TECHNICAL MEMORANDUM

**Re: Phase 3 RI Modification No. 14
Nevada Environmental Response Trust Site
Henderson, Nevada
Ramboll Project No. 1690020169-023**

**RI Phase 3 Modification No. 14
Installation of Shallow Monitoring Wells at Transect I and Slug
Testing of Select Monitoring Wells at the Las Vegas Wash**

Figure
1

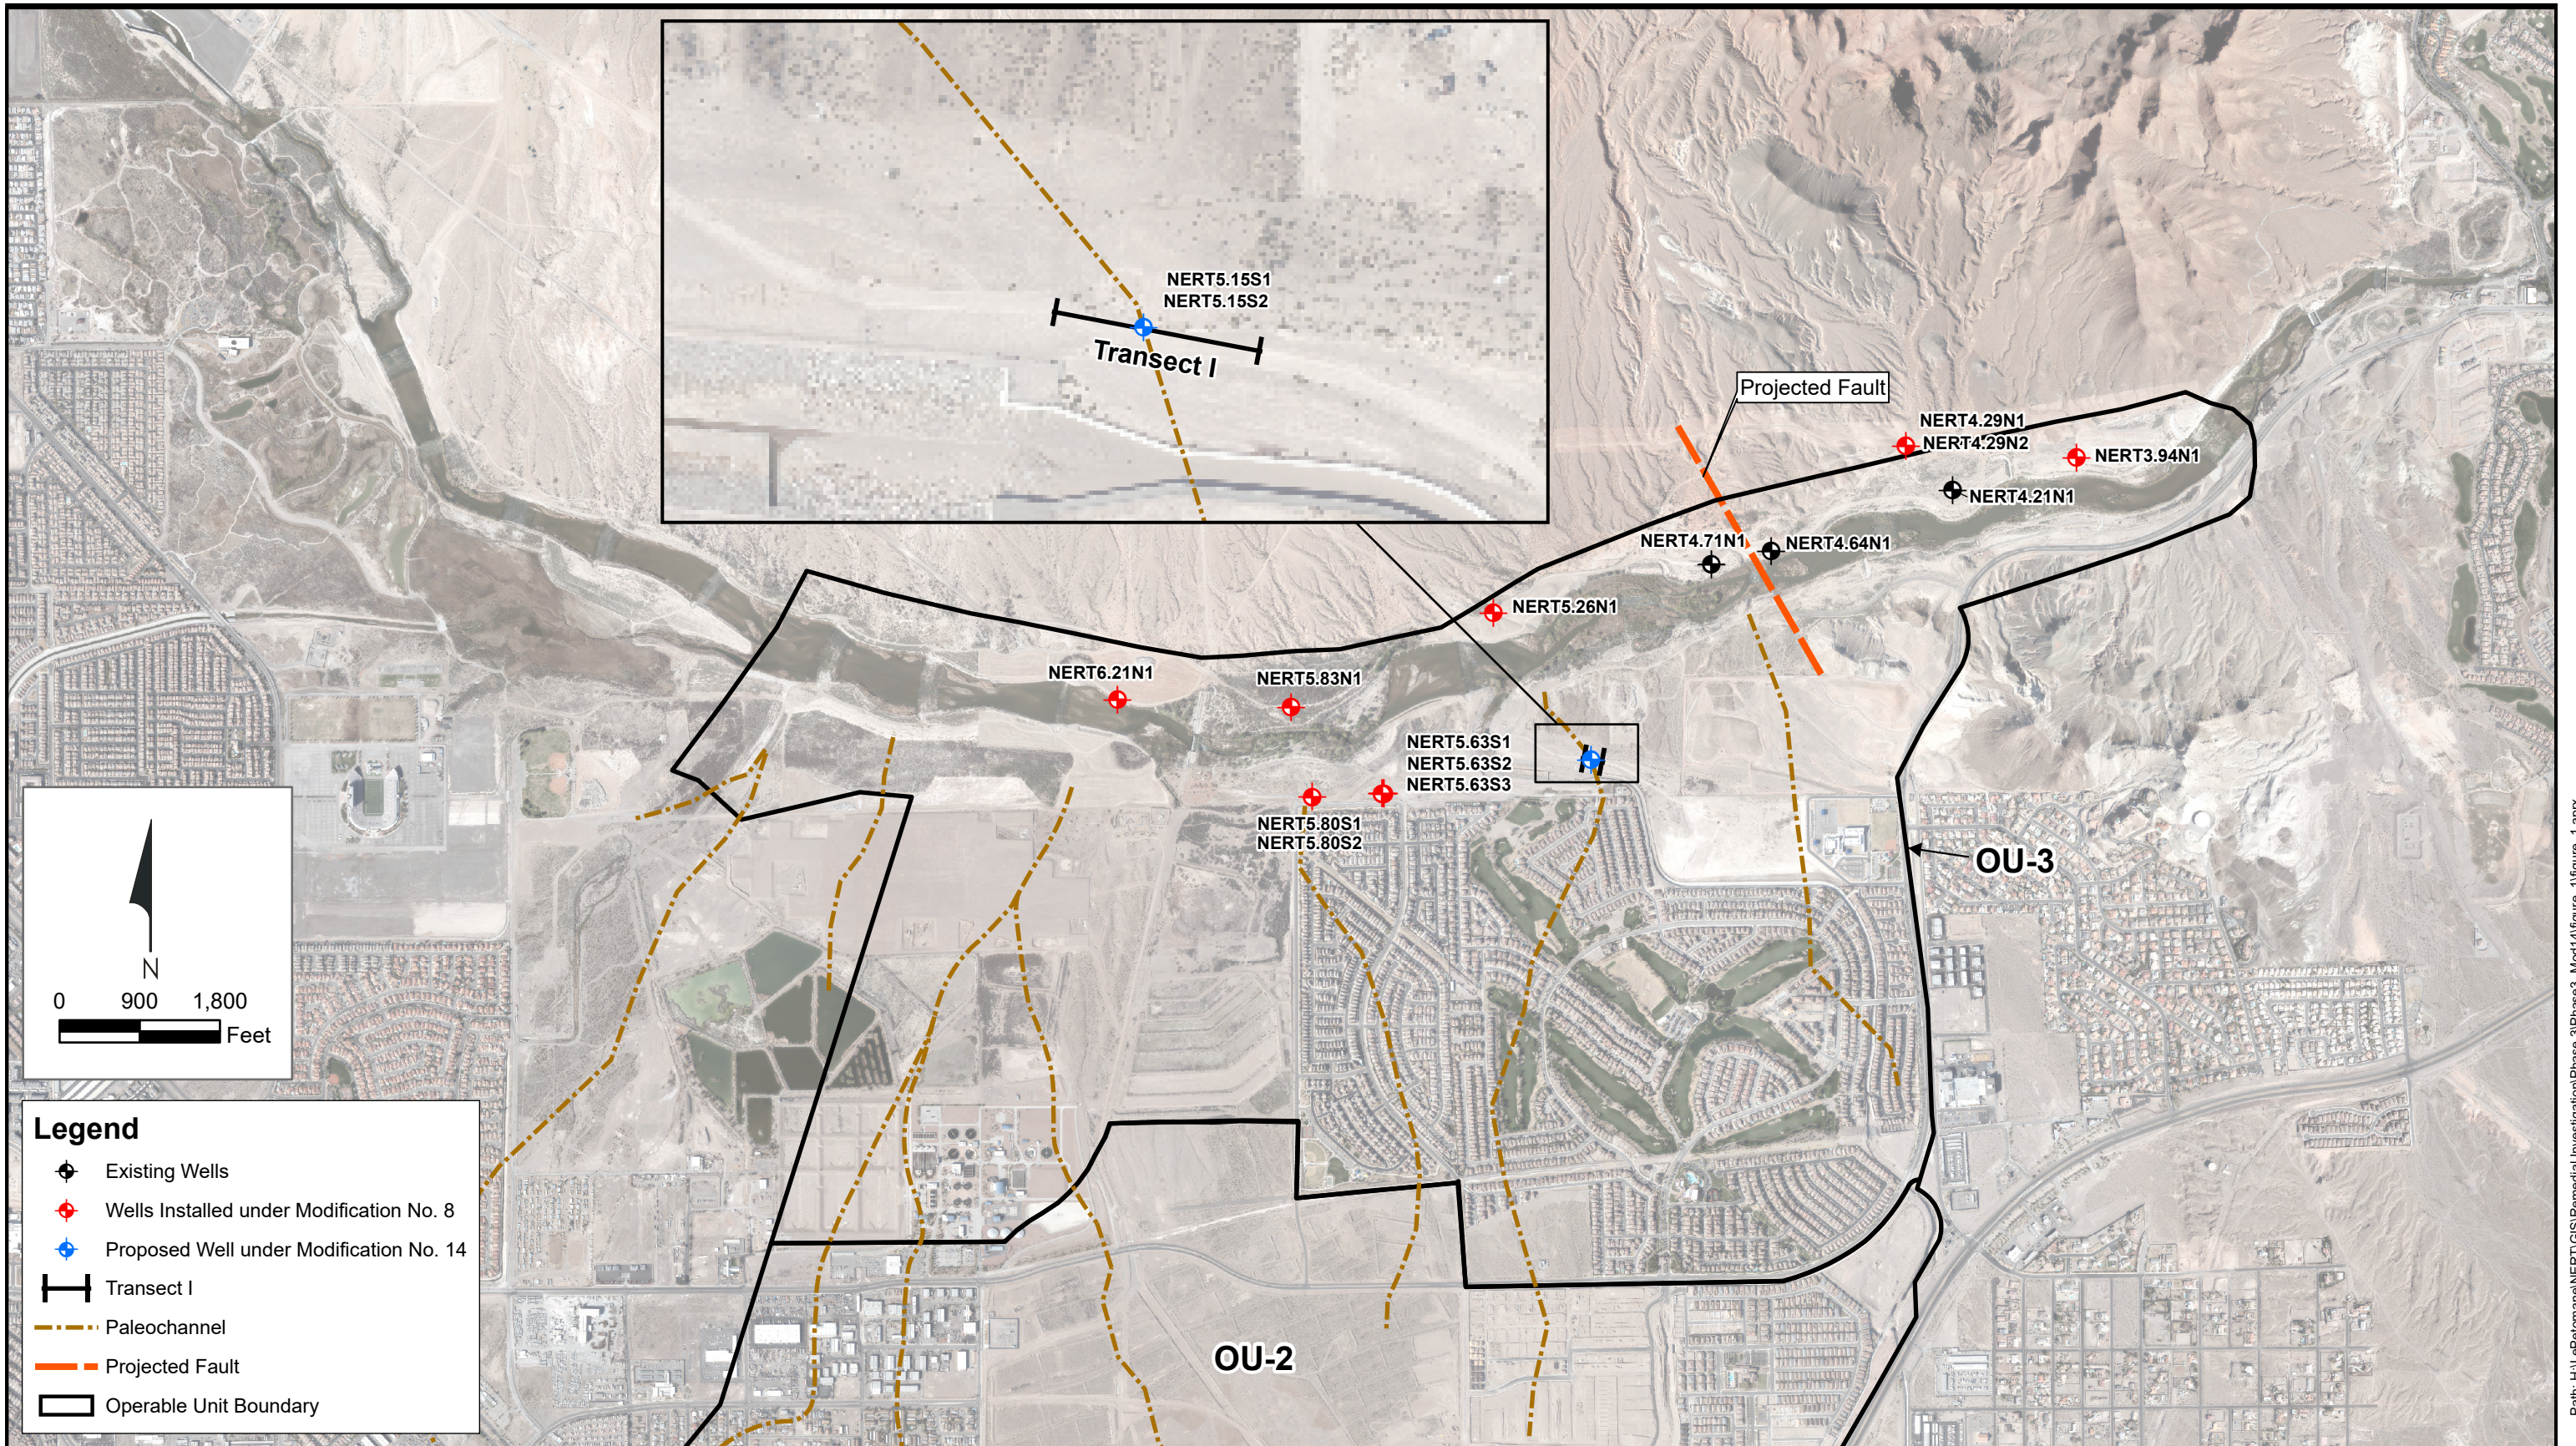
Modification No. 14 further amends the Phase 3 RI scope of work by adding the following tasks: 1) installation of two shallow monitoring wells in the paleochannel near Transect I (identified as Transect 2 in Modification No. 8), and 2) slug testing of 16 shallow monitoring wells near Las Vegas Wash. The collection of this additional data is necessary to fully characterize perchlorate concentrations in groundwater within the Transect I paleochannel and provide additional hydraulic property data near Las Vegas Wash.

As described in Modification No. 8, six soil borings were drilled along Transect I to evaluate the presence of a paleochannel identified during previous investigations. The location of Transect I is shown on Figure 1. At two of the soil borings along Transect I, soil samples were collected at 10-foot intervals to a depth of 90 feet below ground surface (ft bgs) and analyzed for perchlorate. The preliminary, unvalidated soil analytical results are shown in Table 1. Elevated concentrations of perchlorate in soil were detected to a depth of approximately 50 ft bgs. The water table was encountered at approximately 20 ft bgs within the alluvium. The top of the Upper Muddy Creek formation (UMCf) was encountered at approximately 29 ft bgs. Due to the presence of elevated soil perchlorate concentrations were found in both the alluvium and UMCf, a monitoring well is proposed to be installed in each unit as specified below:

- NERT5.15S1 (screened in the alluvium from approximately 15 to 30 ft bgs)
- NERT5.15S2 (screened in the UMCf from approximately 35 to 45 ft bgs)

To acquire hydraulic property data in the portion of OU-3 north of Las Vegas Wash (LVW), single-well hydraulic (slug) testing will be conducted at nine monitoring wells (see Figure 1). In addition, to fill in the gaps in hydraulic property data to the south of LVW, slug testing will be conducted at seven wells at three locations (see Figure 1). These tests will be conducted in accordance with the RI Field Sampling Plan, Revision 1, dated July 18, 2014.
